UNITED STATES PATENT AND TRADEMARK OFFICE

APPLICATION NO.	FILING DATE	FIRST NAMED INVENTOR	ATTORNEY DOCKET NO.	CONFIRMATION NO.
09/837,105	04/18/2001	Hajime Kimura	SEL 253	9007
7590	12/15/2006		EXAMINER	
COOK, ALEX, McFARRON, MANZO, CUMMINGS & MEHLER, LTD. SUITE 2850 200 WEST ADAMS STREET CHICAGO, IL 60606			DONG, DALEI	
			ART UNIT	PAPER NUMBER
			2879

DETAILED ACTION

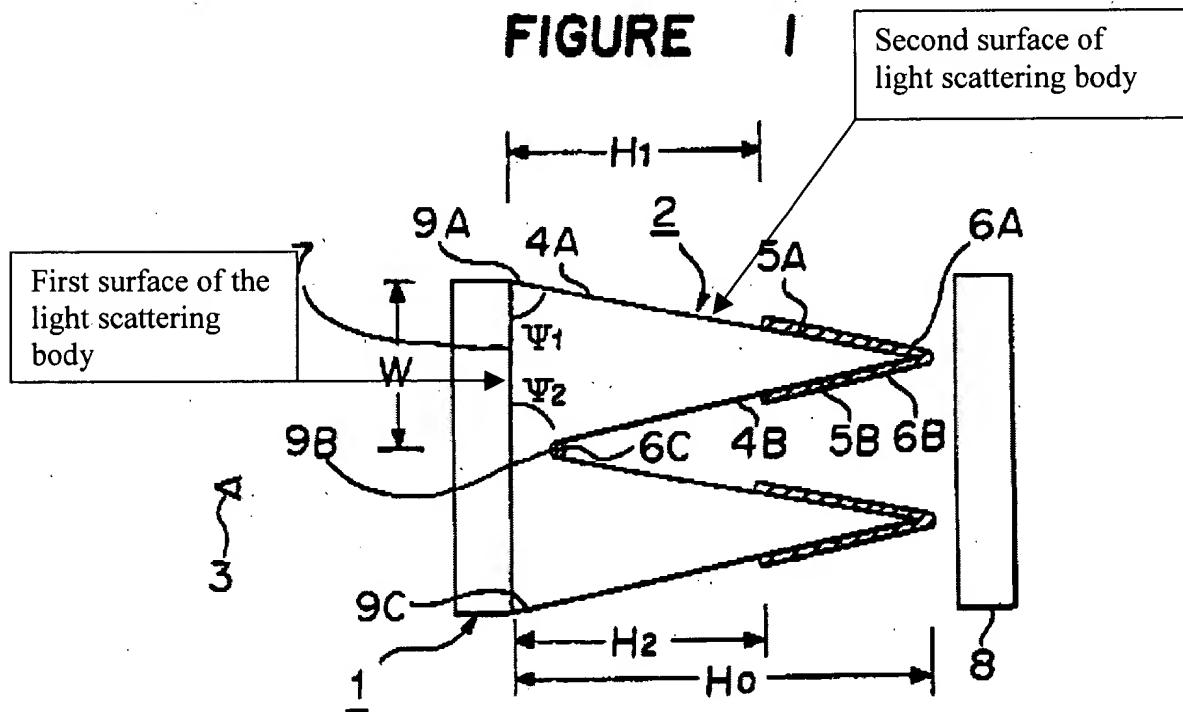
Regarding to claim 78, Abe discloses in Figure 1, a self-light emitting display device comprising a substrate (1); a first electrode (2) formed over a first surface (12) of the substrate; an EL layer (4) formed on the first electrode (2); a second electrode (6) formed on the EL layer (4); and a light scattering body (plurality of prisms) formed over a second surface (11) of the substrate which is opposite to the first surface (12), wherein

an angle between the light scattering body (plurality of prisms) and the second surface (11) is not less than 60 degrees and is less than 180 degrees (see column 3, lines 60-65).

7. Applicant's arguments with respect to claims 56-64 and 78-88 have been considered but are moot in view of the new ground(s) of rejection, provided by the new interpretation of Figure 1, shown below.
